Energy

Proposed Code Modifications

Sub Code: Energy Conservation

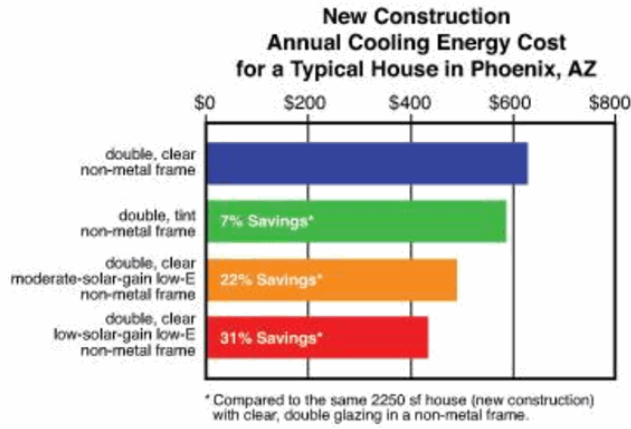
The second graph displays potential cooling cost savings for moving from a moderate solar gain low-e product to a low solar gain low-e product – 22% savings to 31% savings:

A 0.25 SHGC requirement for fenestration is achievable in Florida, and it will bring energy savings, peak demand savings, and equipment cost savings to Florida homeowners.

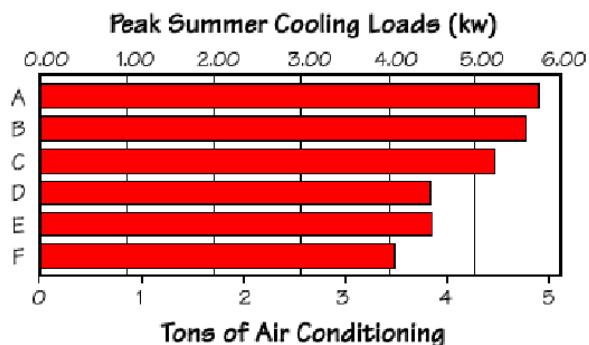
Disapprove Modification 4320

Modification 4320 should be disapproved because it would take a substantial step backward in energy efficiency by completely removing protections against inefficient glazing in homes. RECA wholeheartedly supported the inclusion if the trade-off maximums in written and in-person comments during the drafting phase of the proposed code, and we continue to believe that this section is a crucial part of Florida's energy requirements. The glazing trade-off maximums currently found in Section 402.5 of the 2009 IECC and the draft 2010 Florida Building Code are simple mandatory measures that ensure that all new homes contain high-quality, cost-effective windows that save energy and block unwanted solar gain in warmer climates.

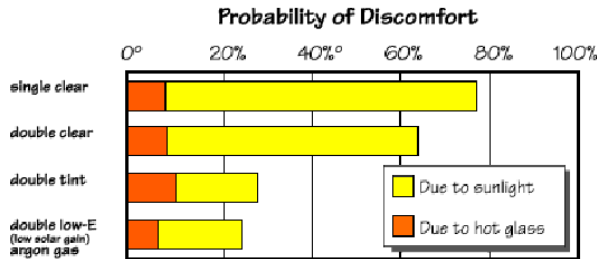
The chart below, again produced by LBNL and displayed on the EWC website, shows the probability of discomfort during summer from sunlight and hot glass. The potential comfort problem from bad windows is even worse in the summer. The summertime probability of discomfort ranges from almost 80% with single clear and over 60% with double clear declining to almost 20% with windows as specified by Section 402.6.

In cooling-dominated climates, windows with low SHGC will protect against hot spots and occupant discomfort, and will make it less likely that occupants will need to adjust the thermostat and use more energy.

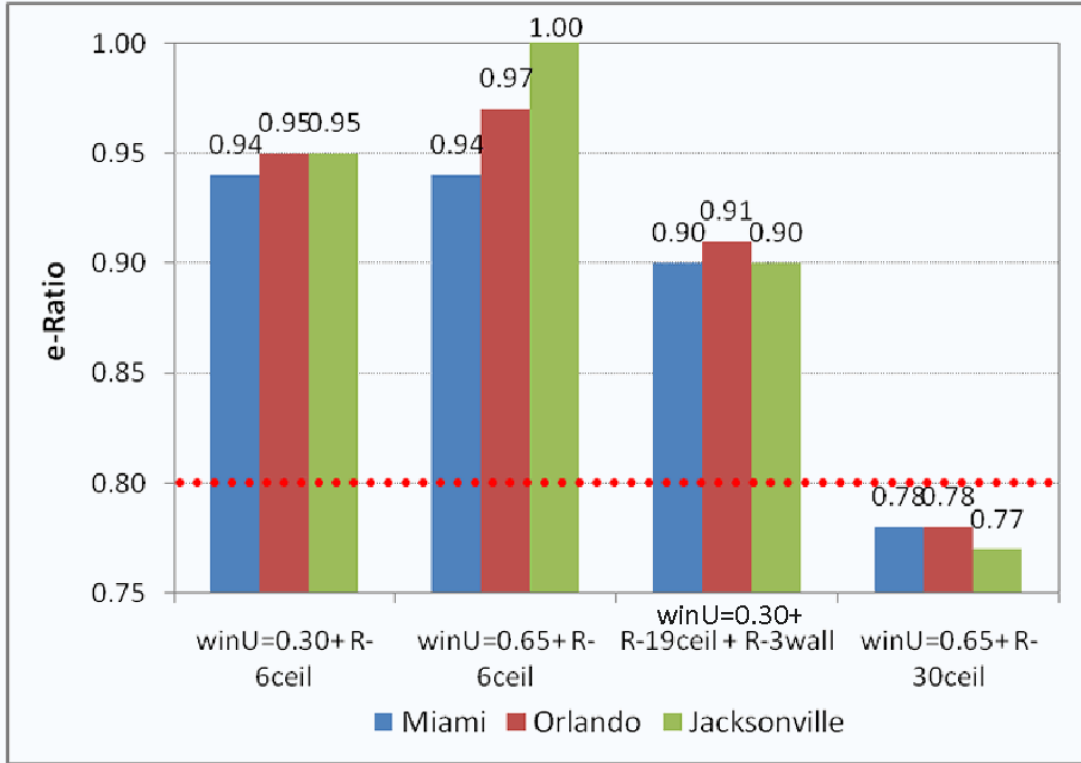
Furthermore, this analysis also finds, as earlier analyses have found, that homes in Florida are not nearly as sensitive to window U-Factor as the Total UA Alternative would imply. Figure 1 provides results from this analysis, showing both the sensitivity to changing the windows U-factor from 0.30 to 0.65 as well as the sensitivity of changing both the window U-factor in this way and simultaneously changing the ceiling insulation from R-6 to R-30, which is its minimum prescriptive requirement. The results show that Florida homes are much more sensitive to this ceiling insulation R-value change than to the window U-Factor change.

passing the Total UA Alternative, it does not pass the 2010 code. That combination results in e-Ratios of 0.83 in Miami, 0.84 in Orlando, and 0.91 in Jacksonville.

This methodology will clearly violate the equivalence goal recommended by the 2010 Energy Code Workgroup and accepted by the Florida Building Commission. The prescriptive and performance methodologies avoid the shortcomings of the Total UA Alternative. Therefore, the total UA approach should not be permitted in Florida's energy code.
